ADDENDUM NO. 2 – BID PACKAGE NO. 1

PROJECT NAME: UNL – Animal Science Reroof – Bid Package I – Standing Seam Metal Roof
UNL PROJECT NUMBER: A102P024

DATE OF ISSUANCE: April 25, 2012
DATE OF BID OPENING: May 2, 2012

VENT PIPE ROOF TERMINATION DETAIL 1
NO SCALE

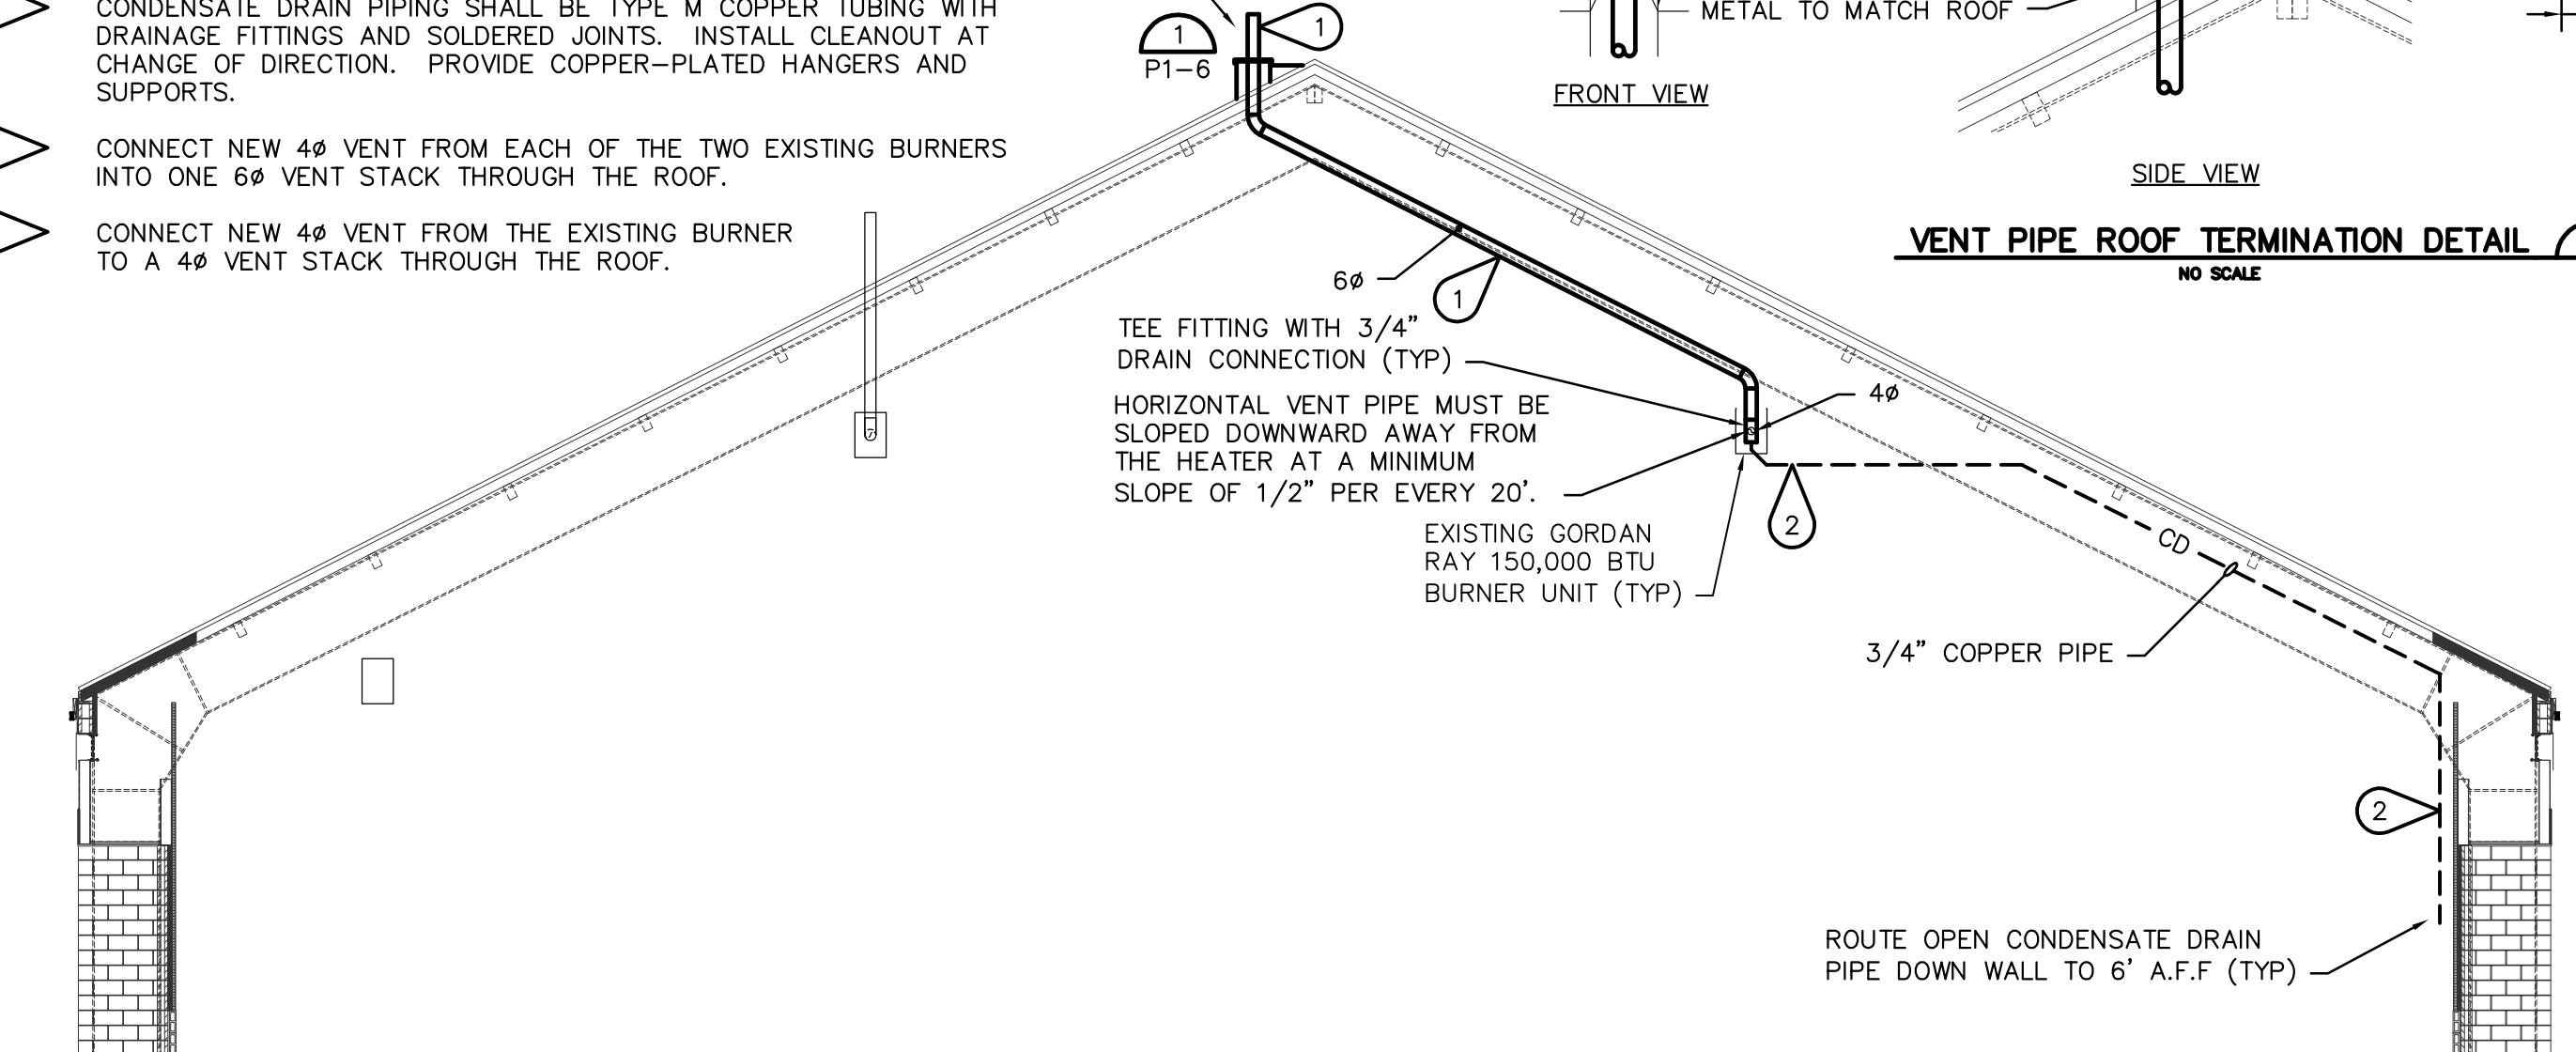
7. At Sheet Note No. 28, add the following: "See attached sheets 1 of 3, 2 of 3 and 3 of 3 from Farris Engineering for mechanical vent requirements. At the roof penetrations, each relocated vent is to have a box base sized to match the existing vent base boxes. Each box is to be pre-finished sheet metal cladding on 5/8" FRT OSB on 2x6 wood blocking with a prefinished sheet metal cricket on the high side. Provide adequate clearance between wood blocking and vent. Flash the box into the standing seam roof per roof manufacturer's current written instructions and details."

- 1 FURNISH AND INSTALL TYPE B DOUBLE WALL METAL VENT TESTED IN ACCORDANCE WITH UL 441. THE INNER SHELL SHALL BE CONSTRUCTED OF 430 STAINLESS STEEL AND THE OUTER JACKET CONSTRUCTED OF GALVANIZED STEEL. FURNISH ALL FITTINGS, THIMBLES, SUPPORT ASSEMBLY, ETC. AND REQUIRED FOR INSTALLATION OF VENT STACK THROUGH THE ROOF. THE STACK SHALL TERMINATE WITH A ROUND CHIMNEY TOP TO EXCLUDE MINIMUM 98% RAINFALL. COORDINATE THE INSTALLATION THROUGH THE ROOF WITH THE GENERAL CONTRACTOR FOR ROOF FLASHING, STORM COLLAR, ETC.
- 2 CONDENSATE DRAIN PIPING SHALL BE TYPE M COPPER TUBING WITH DRAINAGE FITTINGS AND SOLDERED JOINTS. INSTALL CLEANOUT AT CHANGE OF DIRECTION. PROVIDE COPPER-PLATED HANGERS AND SUPPORTS.
- 3 CONNECT NEW 4" VENT FROM EACH OF THE TWO EXISTING BURNERS INTO ONE 6" VENT STACK THROUGH THE ROOF.
- 4 CONNECT NEW 4" VENT FROM THE EXISTING BURNER TO A 4" VENT STACK THROUGH THE ROOF.
